Track Standards Bulletin #6

4 November 2021

Bulletin No. 006

Figure 42. Clearance Diagram for Signal and Electrification Structures

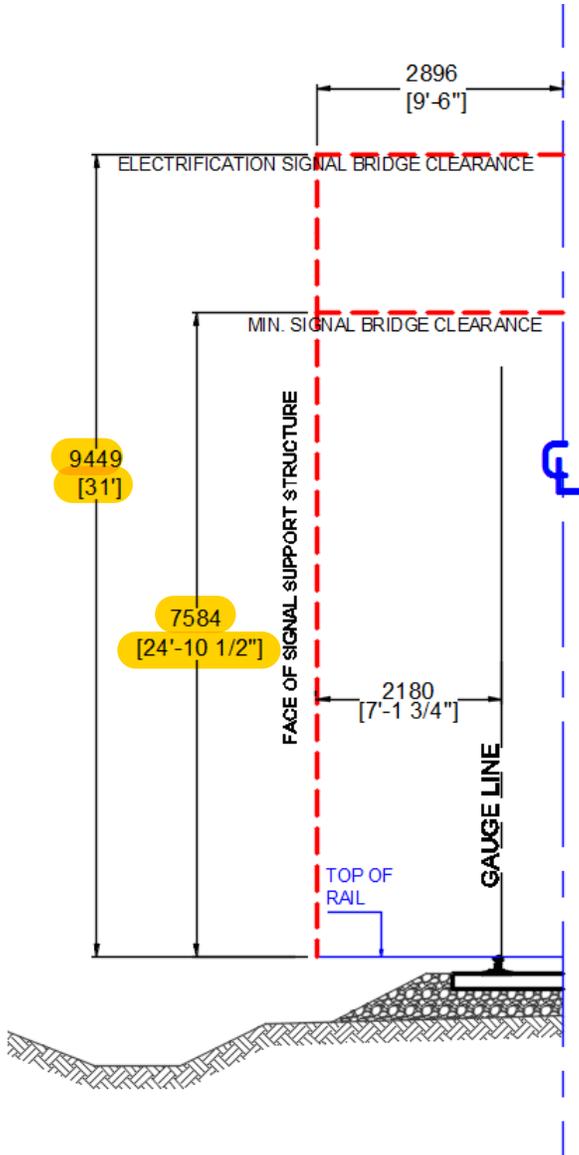
Refer to Appendix X Figure 42 and replace with:

Note: For use with tangent track only. For curve correction, consult with the CM Sr. Manager of Track and Structures. Refer to Metrolinx General Guidelines for Design of Bridges and Structures for full details on design requirements. Horizontal clearances to signal bungalows shall be per the current approved SCP.

- FOR USE WITH TANGENT TRACK ONLY
- FOR CURVE CORRECTIONS, CONSULT THE CM SENIOR MANAGER OF TRACK AND STRUCTURES
- FOR FUTURE TRACK REQUIREMENTS, CONSULT RAIL CORRIDOR INFRASTRUCTURE
- HORIZONTAL CLEARANCE MAY BE REDUCED TO 9FT DEPENDING ON SITE CONDITIONS, SIGHTLINES, AND OTHER FACTORS. APPROVAL WILL BE REQUIRED IN WRITING FROM THE CM SENIOR MANAGER OF TRACK AND STRUCTURES, AND THE RCI SENIOR MANAGER OF SIGNALS AND COMMUNICATIONS
- REFER TO METROLINX GENERAL GUIDELINES FOR DESIGN OF RAILWAY BRIDGES AND STRUCTURES FOR FULL DETAILS ON DESIGN REQUIREMENTS
- HORIZONTAL CLEARANCES TO SIGNAL BUNGALOWS SHALL BE AS PER THE SCP's
